## **Addendum: Converse Avenue Reconstruction Plan RFP**

**August 28, 2020**

Figure 5 – Section 20 Proposed Road Network

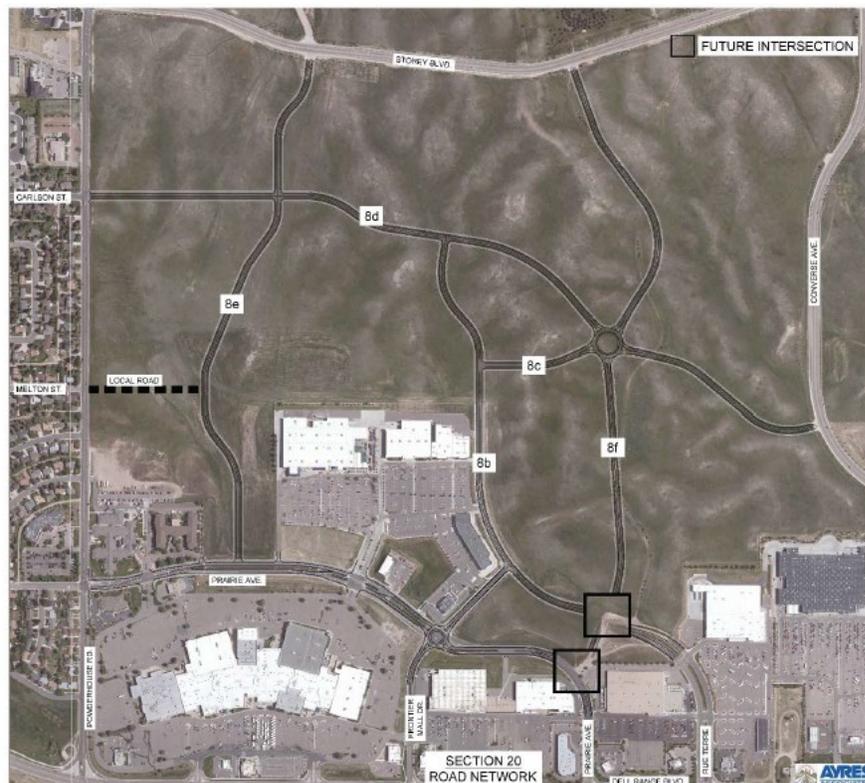
- When are we to assume that the Carlson Street extension will be built? Also, will this extension provide an intersection with Rue Terre? This will impact the traffic circulation on Converse as well as the level-of-service calculations and signal warrants along the corridor.

**Development has begun on the west side of Section 20 at Carlson and Powderhouse, as LCSD#1 is planning a 5-6 school south of Carlson between Powderhouse and Ft. Laramie Trail, and east side development is anticipated in the next couple of years as an approximate 600 unit apartments are planned. While we cannot perfectly predict when the Carlson Street extension will be built all the way through Section 20, we can confirm the extension will intersect with Rue Terre, as seen in the graphic below from the adopted Section 20 Plan.**
